Access Compliance Report

Public Rights-of-Way (Curb Ramps)

| Intersection ID: 43106 | Main Street: BRIARCLIFF_PL | Cross Street: SHARON_RD | Location: NW |
| ADA ID: DB22ECD368B2 | Ramp Type: Directional1 | Initial Pass/Fail: Fail | Overall Compliance: No |

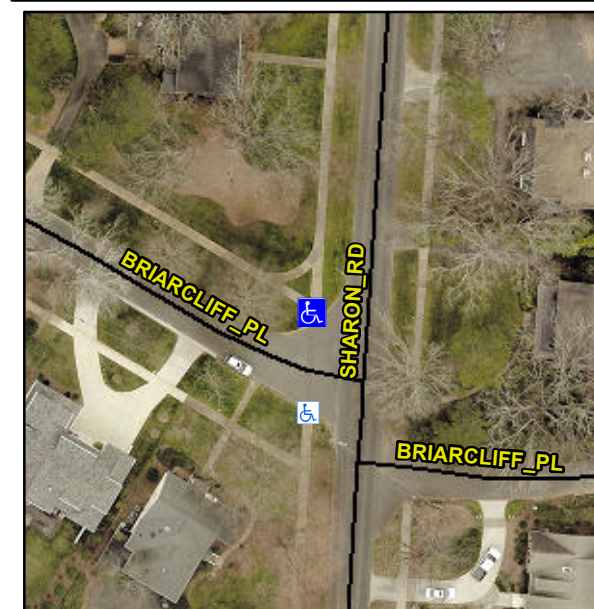
| Compliance | Description | Data | Compliance | Description | Data |
|------------|-----------------------|-------|------------|-----------------------------|------|
| No | Ramp Slope (%) | 8.6 | N/A | Grade Break XSlope (%) | 0.0 |

Remove & Replace Entire Ramp.

R304.2.2
